HISTORIC AND DESIGN REVIEW COMMISSION

HDRC CASE NO: 2023-182
ADDRESS: 320 MADISON ST
LEGAL DESCRIPTION: NCB 744 BLK 3 LOT 16
ZONING: RM-4, H
CITY COUNCIL DIST.: 1
DISTRICT: King William Historic District
APPLICANT: Maggie Wilmoth
OWNER: Maggie Wilmoth
TYPE OF WORK: Construction of a 2-story rear accessory structure
APPLICATION RECEIVED: May 08, 2023
60-DAY REVIEW: Not applicable due to City Council Emergency Orders
CASE MANAGER: Rachel Rettaliata

The applicant is requesting a Certificate of Appropriateness to construct a 2-story rear accessory structure.

Elevation 3

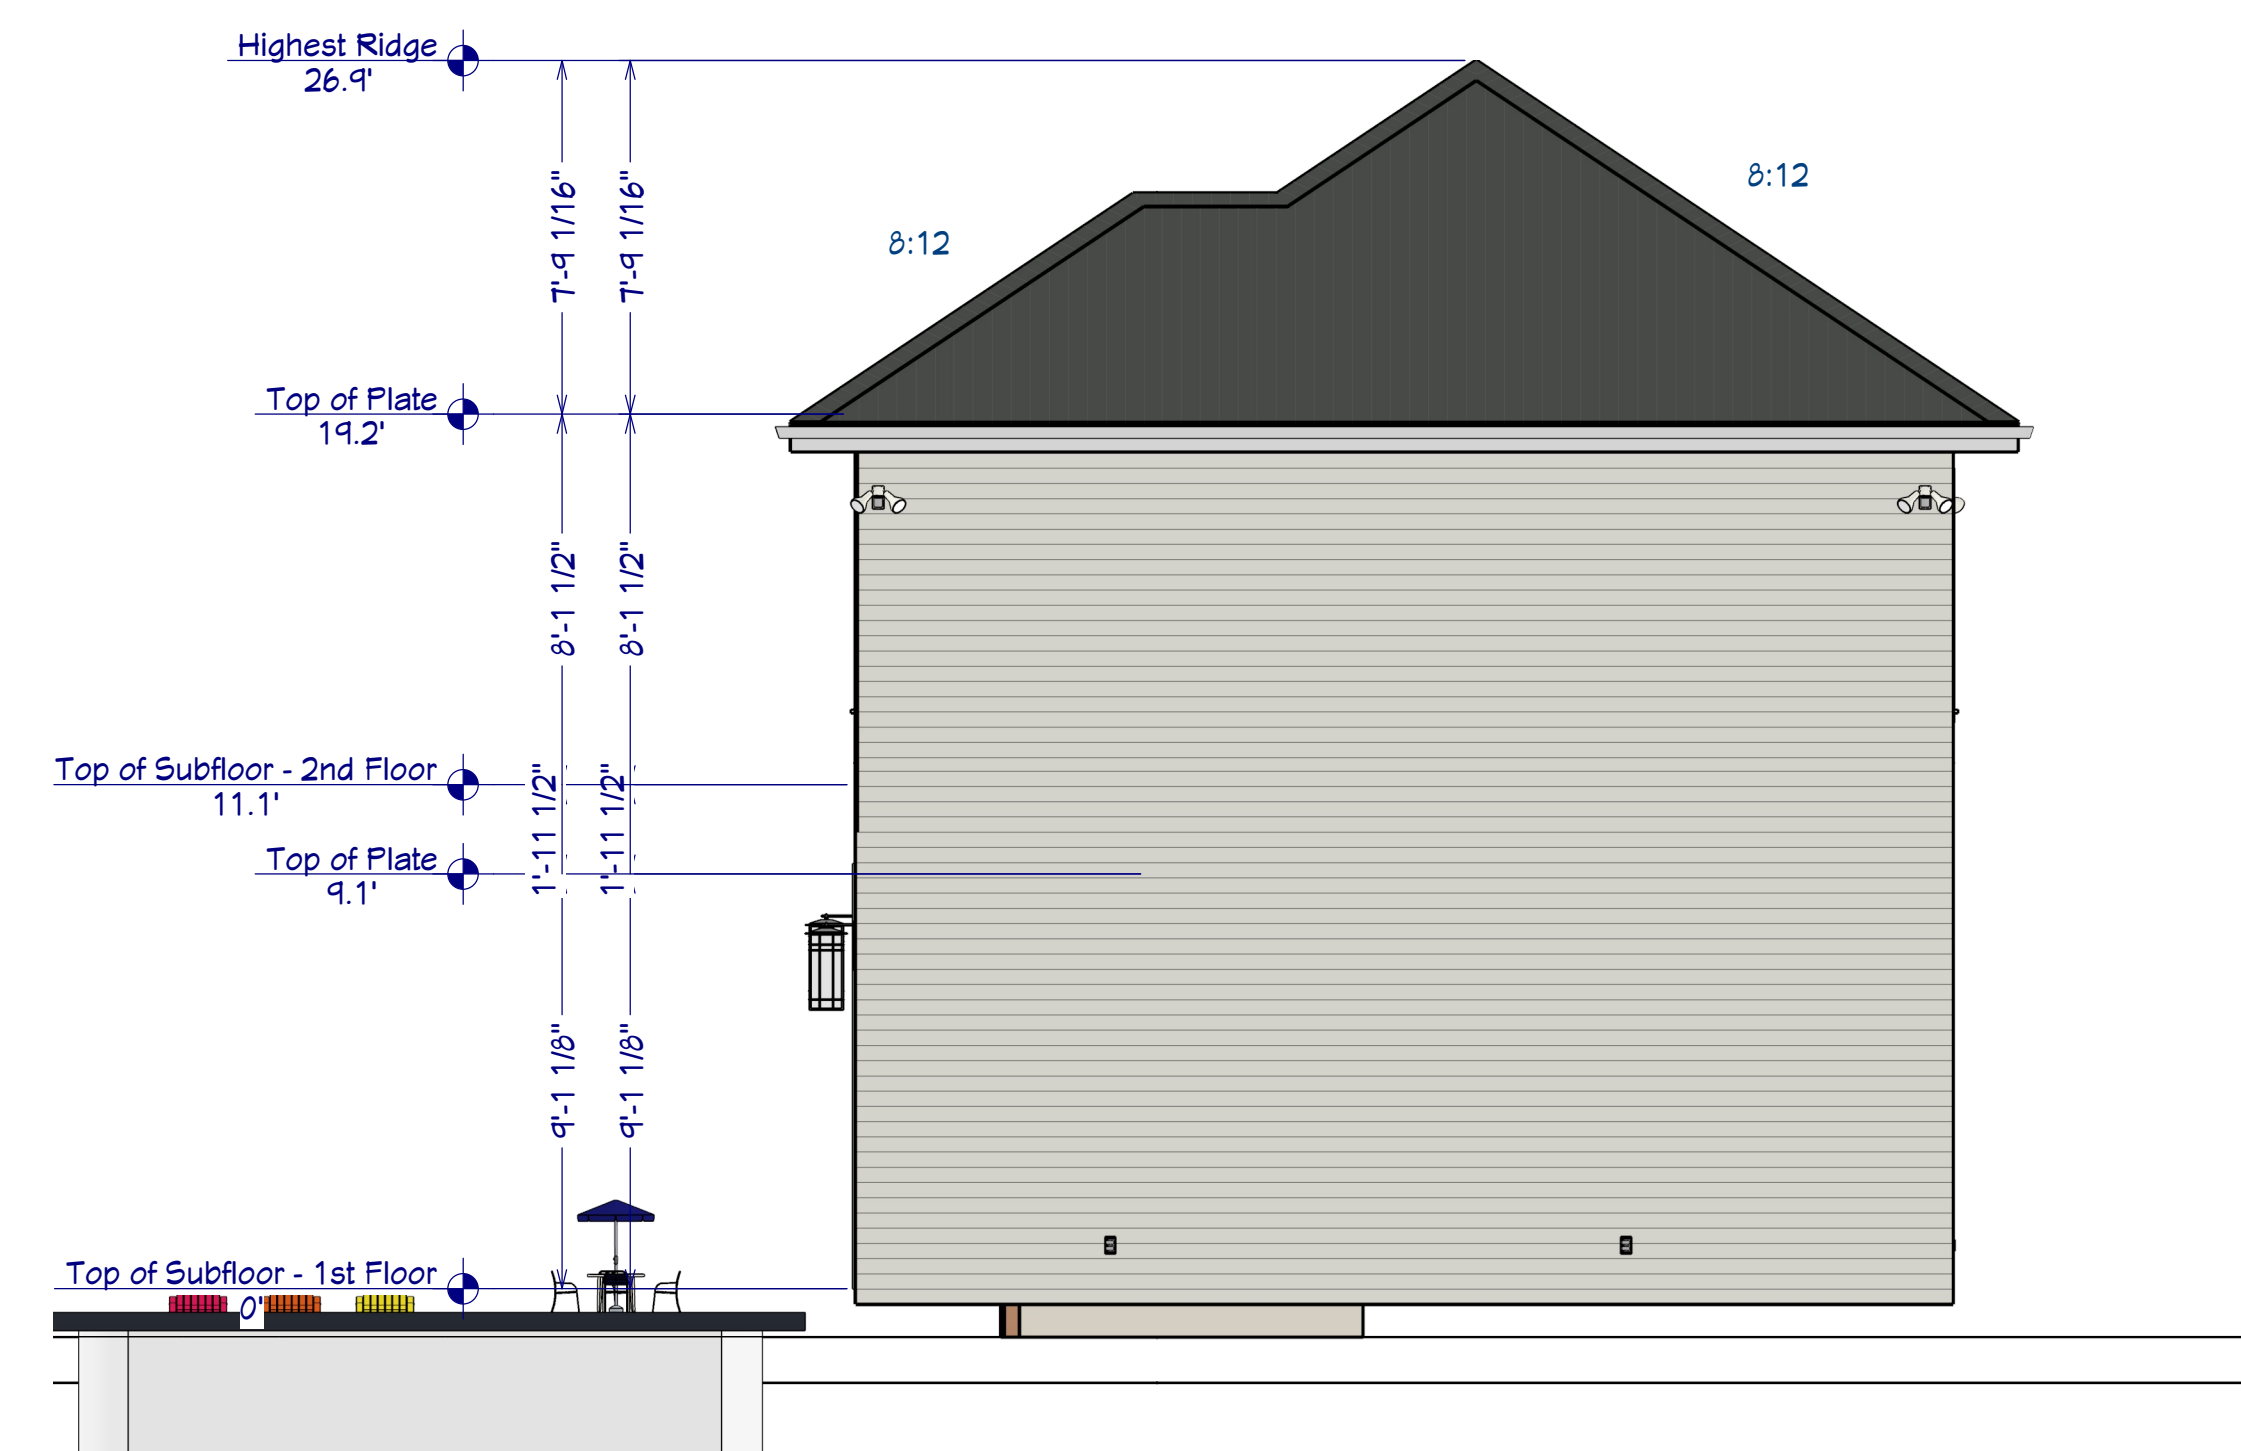
- i. That the applicant submits updated elevation drawings that propose architectural details that are in keeping with the Historic Design Guidelines and do not feature Juliet balconies based on finding j.

JULIET BALCONIES HAVE BEEN REMOVED
